FILE P. I. No. 621082-, Chattooga County
EDS00-0027-00(095)
Summerville Bypass

SUBJECT APPROVED REVISED PROJECT CONCEPT REPORT

SUBJECT Revised Project Concept Report

REVISED PROJECT CONCEPT REPORT
EDS-27(95), P.I. NO. 621082
Chattooga County

TYPICAL SECTION I

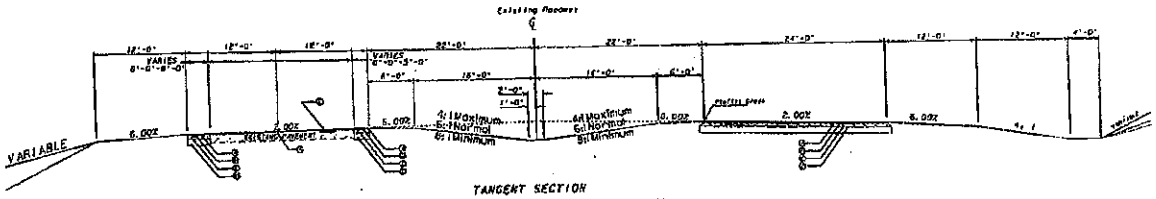
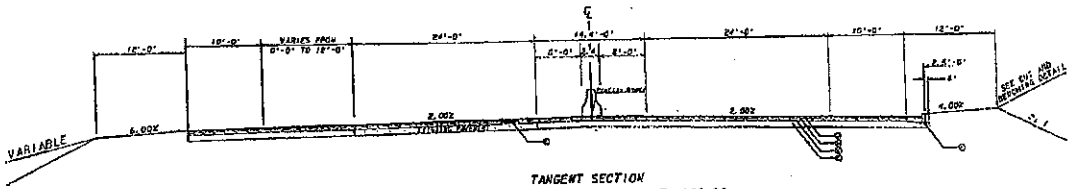
The concept has been revised to call for two 12' lanes in each direction with a 44' depressed median from CR 329 extending northward for 870', then transitions to a 14.5' median barrier for 5800'. Then it will proceed northeasterly on new location to continue the four-lane highway along Taylor's Ridge to bypass the town of Summerville and then return to the existing alignment of SR1/US27 near East Trion. The width of the depressed median will vary from 44' to 32' in areas of high cut or fill in order to minimize construction limits.

The original concept called for a 4 lane 44' depressed median beginning at CR 329 northward one-half mile, then transitioned to a 14' flushed median for approximately one mile, then at the crest of Taylor Ridge transitioned to a 4' median for approximately 0.7 mile. From this point the proposed typical section called for a 44' depressed median for the remainder of the project.

Functional classification for the Summerville Bypass is rural principal, and the speed design is 55 mph from station 50+00 to station 183+00. According to Design Policy Manual a 44-ft depressed median or a positive barrier system required for all arterials with design speeds greater than 45 mph. (The current Design Policy Manual would not allow a 14' flushed median to be used in this instance.)

Also In order to minimize the impacts to sliding areas, stream and the construction limits in areas of high cuts or fills we used Median barrier instead of 44-ft depressed median.

A suggestion within the offices (Road Design, OMR and Environmental/Location) was that the beginning of the alignment be shifted 40' west of the current alignment within STA 99+00 and 175+00.

With the 40' shift and Median barrier we are minimizing construction limits in areas of high cuts or fills.

TYPICAL SECTION 2

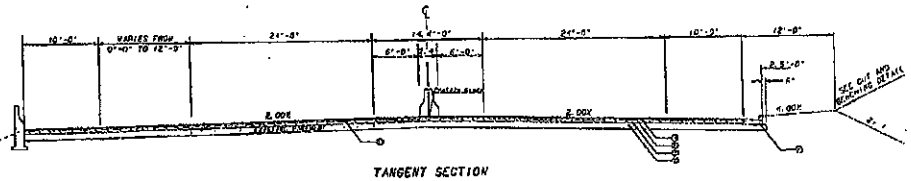
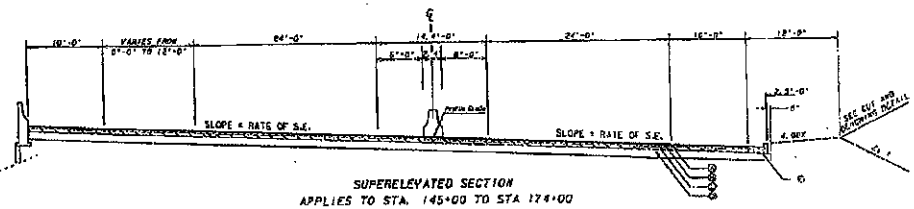
Office of Materials and Research found evidence of major sliding of the slopes within the southernmost portion of the project within STA 95+00 and STA170+00. Many of these areas contain a large amount of colluviums; loose rock and soil at the base of steep slopes. After heavy rains, areas of the existing roadway within this section erode 6" to 1' gaps that require immediate repairs.
